# Bedroom 1's bathroom · design review F-05 · accept the route (A) or a private bathroom (B)? · Taif / Palm House · A ADOPTED · B NOT ADOPTED: young children's room (owner, V9.0)

**OPTION A ADOPTED by the owner (2 Nov 2026): no private bathroom; the wet areas stay grouped in the two clusters; night lights along the route.** 2 Nov 2026, after the stair flip (option B, F-b) · bedroom 1 is the north-east room over the maid wing, 15.75 m² on axes, 13.9 m² clear, one room without a bath · nothing in the design files changes until the owner decides · all sizes assumed

# Plumbing, structure and windows for B2 · B1 for the record · the comparison · recommendation · the decision needed

# B4 (3 Nov 2026) · an en-suite shower room in a “hotel layout” for bedroom 1 · studied, NOT applied: the acceptance criteria 2 and 3 fail in every variant · NOT ADOPTED: young children’s room (V9.0)

bedroom 1 · A · 1 m = 0.95 cm · north up · brown dotted = the ground floor below

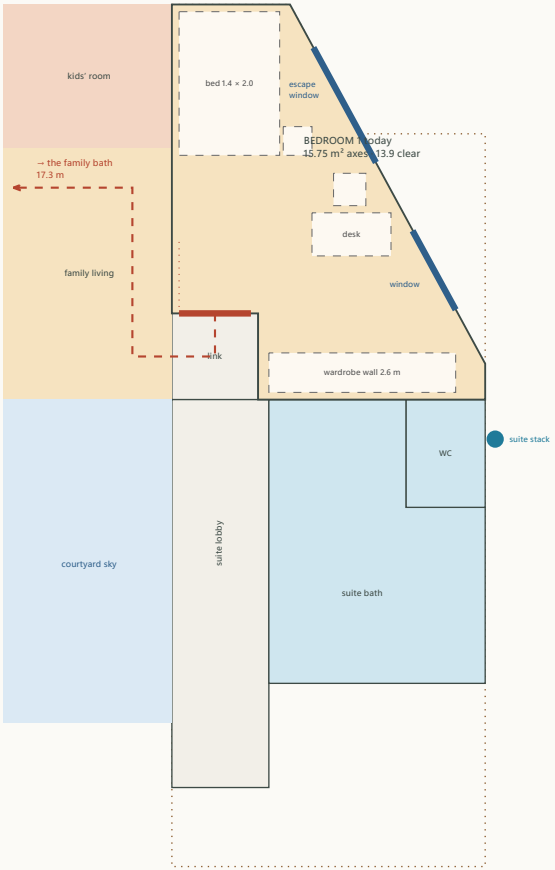
- **The walk, measured after Part 1** (the stair flipped, the family bath enlarged northwards; its door stays at x 4.25, y 9.3–10.3): bedroom 1's door → the family link → the family living, behind the sofa → the gallery's north part, past the stair arrival → the gallery → the bath's door: **17.3 m** (the same as before the flip: the bath grew, its door did not move). Five spaces, two of them lived in (the living, the gallery).

- **Who shares the family bath:** bedroom 1 (17.3 m), bedroom 2 (2.7 m), the kids' room and the family living (a bedroom later); bedroom 3 and the suite have their own. Since F-b it has **two compartments** (a WC by the shaft and the shower + double basin), so two children at once.

- **Comfort:** a child or a guest in bedroom 1 crosses the **family living** at night and in the morning, in sight of whoever is there; 17 m is the longest bathroom walk in the house (the suite's is 0, bedroom 3's 2.7, bedroom 2's 2.7).

- **Cost:** nothing; the plumbing stays as it is.

bedroom 1 · B2 · 1 m = 0.95 cm · north up · brown dotted = the ground floor below

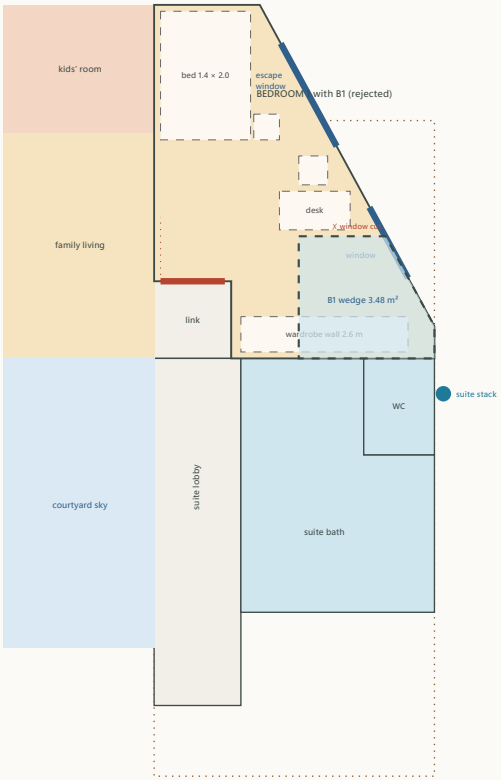
- **B2 (the best, drawn):** a bath along bedroom 1's **south wall**, x 10.6–13.311, y 5.0–6.5, its east end following the cut wall: **3.79 m² on axes, 2.49 × 1.3 clear less the slant ≈ 3.0 m²**: a walk-in shower 0.9 × 1.2 at the east end (its corner 0.02 m west of the cut wall), the WC in the middle facing north, the basin on the west wall, a **sliding 1.0 m door** from the room (no swing), a **small window on the cut wall** (y 5.35–5.85, sill +1.60, obscured). It is **next to the master suite's wet stack**: the pipes run 2.5 m east in the bath's own floor zone to the suite's stack outside the east wall (y 7.05), **over the GF maid room only** (the kitchen and its hood zone start at y 7.0; nothing over the master bedroom).

- **Bedroom 1 with B2: 11.96 m² on axes, ≈ 10.3 m² clear** (was 15.75 / 13.9): the bed 1.4 × 2.0 stays on the west wall with its bedside table, the desk and chair under the escape window, the wardrobe wall (2.6 m) becomes **two wardrobes, 1.3 m on the bath's wall and 0.9 m on the west wall** (2.2 m in all); the door's swing stays clear; the **escape window stays the room's** (the fire study unchanged); the second window (y 4.15–5.25) lights the desk. Still a full bedroom (a 1.4 bed, a desk, 2.2 m of wardrobe), no longer a two-bed room.

- **Drain:** the shower, the WC and the basin to one branch running east along the bath's south side to the **suite's stack** outside the east wall (y 7.05), 2.5 m; the branch crosses the room's south wall line at x 13.311 and turns south outside the wall for 0.6 m (or a second stack beside the suite's; the MEP engineer). **Over the GF maid room only**: not over the kitchen (y ≥ 7.0), its hood zone (the east wall y 10.2–11.2) or the master bedroom (x 8.95–13.311, y 11.9–19.25).

- **Structure (`studies/structure.typ`):** the maid wing's first-floor bay is a **solid 0.20 slab** spanning east–west 4.36 m to the cut wall; a 0.15 depressed zone cannot be cut from 0.20. Two ways, the engineer's choice: **(i)** cast the bay 0.35 thick under the bath with its top depressed 0.15 (as the suite bath, X10), or **(ii)** keep the slab and run the pipes **below** it in the maid room's ceiling void (the maid room gets a gypsum ceiling anyway; 3.1 m clear left) with a wall-hung WC and a shower tray raised ≈ 0.10. The bath's walls are light partitions on the slab (no beam; B6 at y 6.5 is the room's south wall beam, untouched).

- **Windows:** the bath's small window on the cut wall faces the lane side (obscured glass, a vent); the room keeps both its windows. **Ventilation:** the window plus an extract fan to the roof riser is not available here: an extract through the cut wall (a small louvre) or a duct in the ceiling void to the east wall.

- **Neighbours:** the maid room below hears the bath (pipes in a ceiling void: wrap them); the suite's WC closet shares the stack; the family link and the suite lobby are untouched; the family bath keeps serving bedroom 2, the kids' room and the living.

bedroom 1 · B1 · 1 m = 0.95 cm · north up · brown dotted = the ground floor below

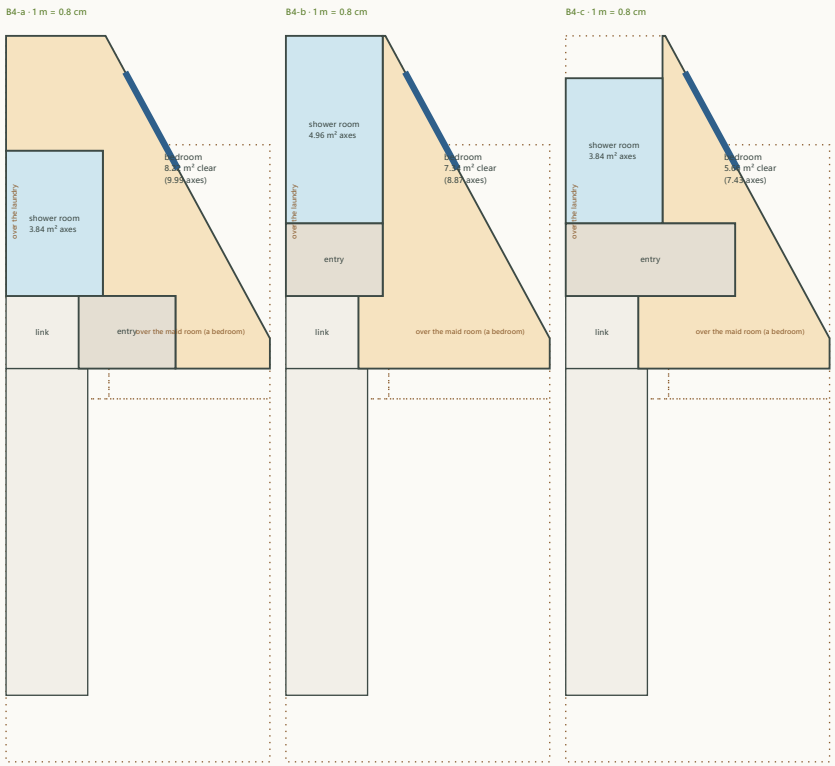
- **B1 (the south-east wedge, dashed on page 2):** x 11.2–13.311 on the cut wall, 3.48 m²: a wedge, its north wall cuts the second window (y 4.15–5.25) and leaves 0.8 m of the wardrobe wall: worse than B2 for the same plumbing. **B3 (the north-east corner):** the north-east corner (x 10.6–12.0, y 1.0–2.9) holds the room's **escape window** and the bed's head wall: a bath there moves the escape window and the bed; rejected without drawing.
